3rd Further Information

**Proposed Temporary Shop and Services with Ancillary Facilities and Associated Filling of Land
for a Period of 5 Years in “Village Type Development” Zone,
Various Lots in D.D. 111 and adjoining Government Land, Pat Heung, Yuen Long, New Territories**

(S.16 Planning Application No. A/YL-PH/1094)

FIGURE NUMBER
 FIGURE 3

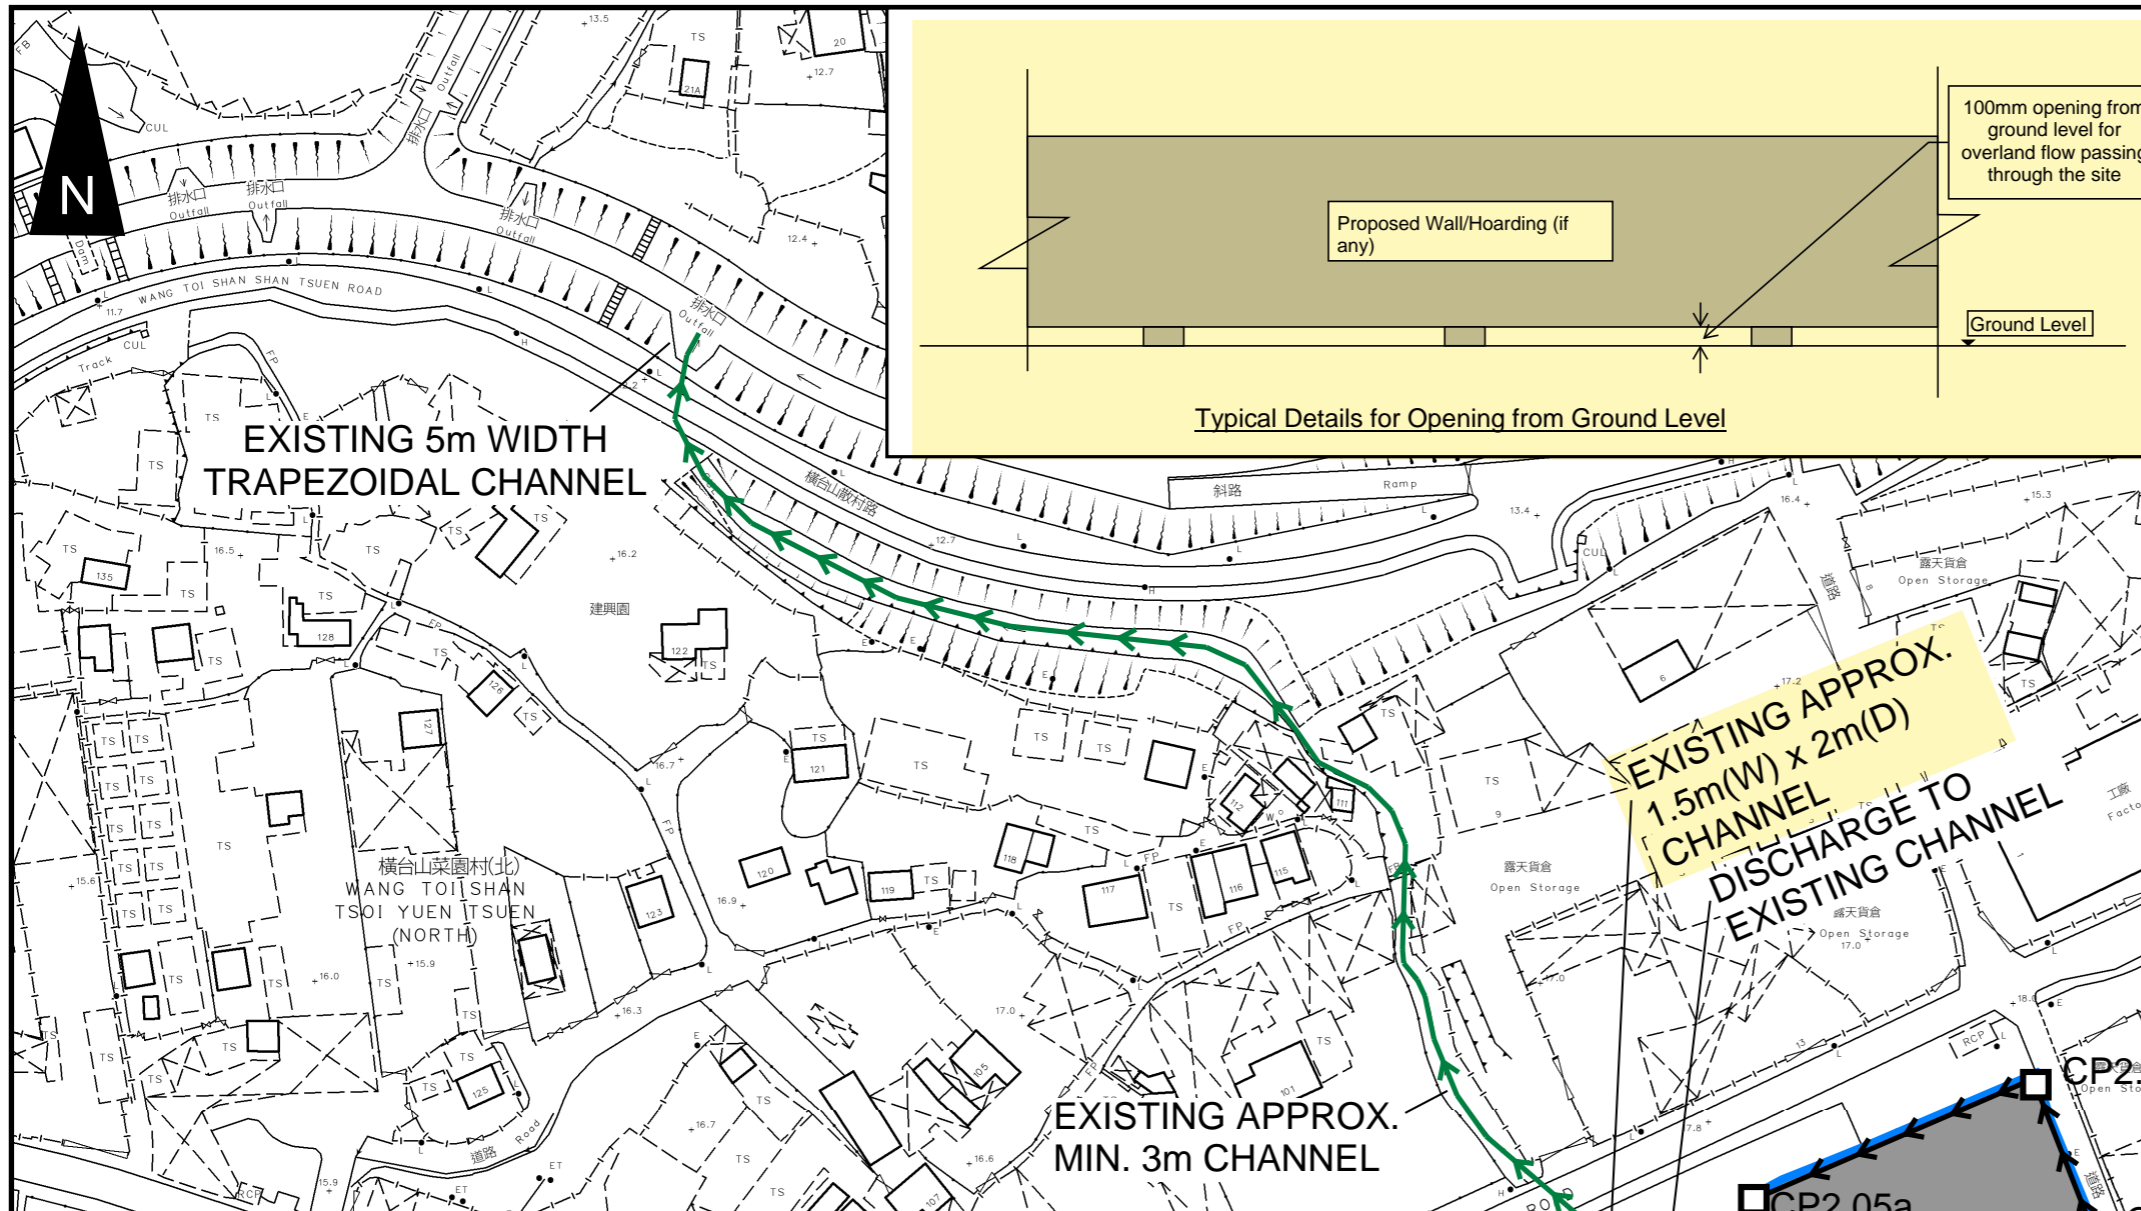
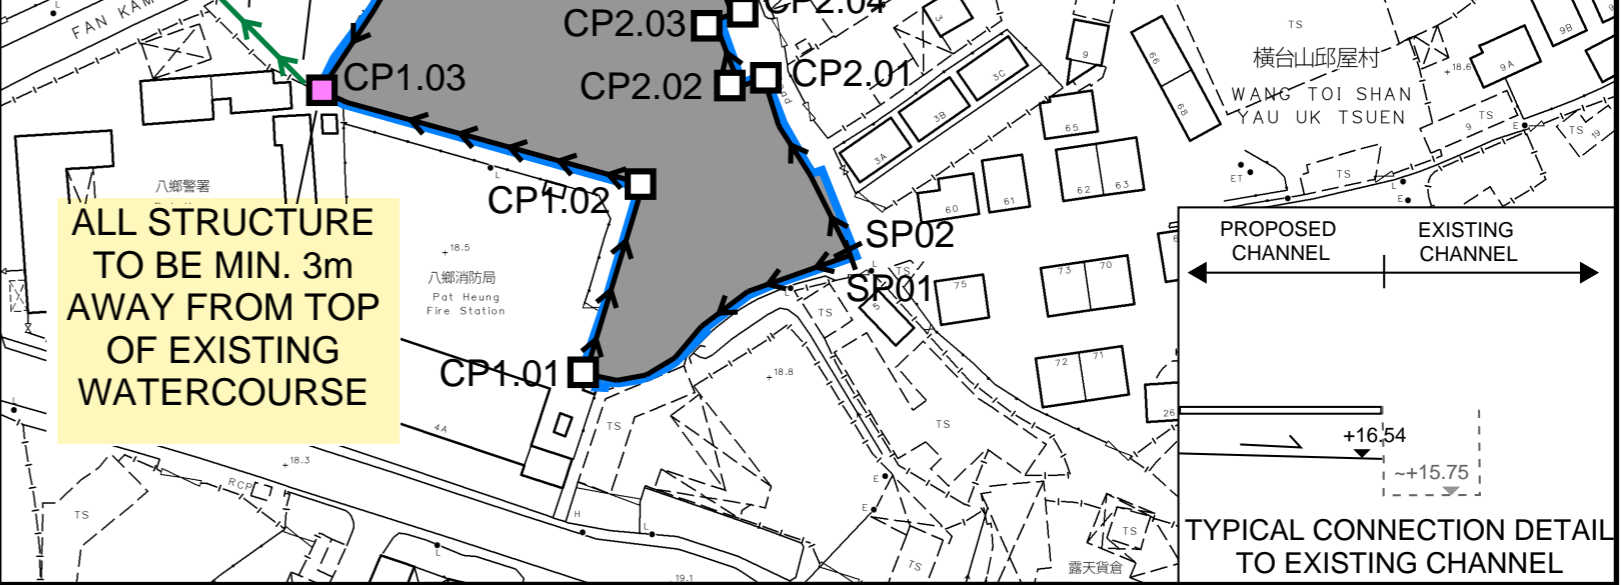
Comments of the Chief Engineer/Mainland North, Drainage Services Department (CE/MN, DSD)		
(1)	<p>According to R-to-C, it is noted that a 100mm opening/gap will be provided at the toe of the proposed hoarding. Please provide the details of this opening/gap on the drainage plan (Figure 3) for review.</p>	<p>Noted. The details is updated in Figure 3 in Appendix II for your perusal.</p>

(2)	<p>According to the record, there is an existing watercourse at both northwest and southern sides of the application site. Referring to R-to-C, it is noted that all proposed works and structures should be placed 3m away from the top of this watercourse. Please clearly indicate and state the above on the drainage plan (Figure 3) for record.</p>	<p>Noted. Figure 3 is updated for your review in Appendix II. The structures near the northwest side of the site would be at least 3m away from the top of the northwest watercourse.</p> <p>Photos of the well-established southern watercourse (open channel/ box culvert) are appended for your reference. Please kindly note the existing structures have been situated near/above the opening channel/box culvert since 2007 (about 20 years, see aerial photos) and they are in good conditions. The concerned channel and box culvert are well maintained. The applicant intends to keep the existing structures in the original location.</p>

<p>drain at both sides. Please provide more site photos at different locations and views showing the current condition of the existing 1.5m width channel near the proposed discharge point (CP 1.03), the cross road drain with its inlet and outlet at Fan Kam Road and the existing 3m width channel for review. In accordance with Views 1 and 2, the existing channel near the proposed discharge point at CP1.03 is about 1.5m width and 2m depth. Please update the size of this existing channel at this section on the drainage plan (Figure 3) for record.</p>

SITE PHOTOS

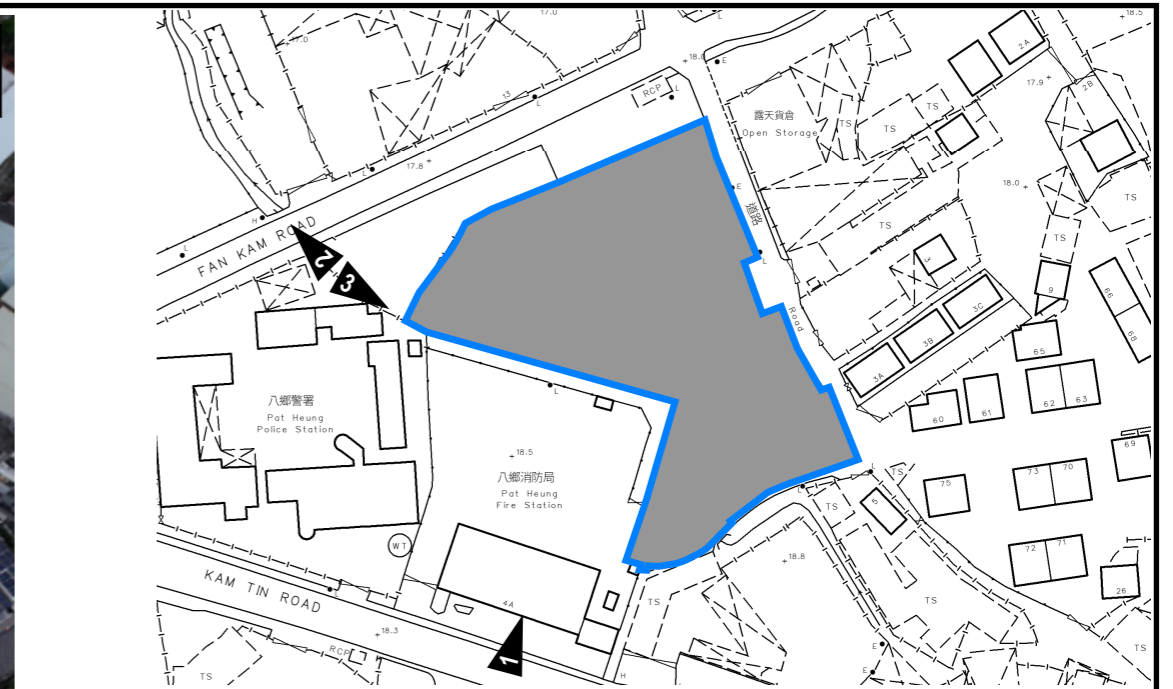
(3)	<p>Referring to Views 1, 3 and 4, there are some overgrown vegetation found inside the existing channel. Please consider clearing these overgrown vegetation and submit update photos for review. Besides, please also indicate the size of the cross road drain at Fan Kam Road for review. The submitted photo (View 4) cannot show the existing condition near the inlet and outlet of this cross road</p>	<p>Further to the discussion with DSD, please kindly note the applicant has requested YL/DO and YL/DO agreed to clear the overgrown vegetation. Photos after clearing works and photos of cross road drain at Fan Kam Road would be provided upon completion.</p>
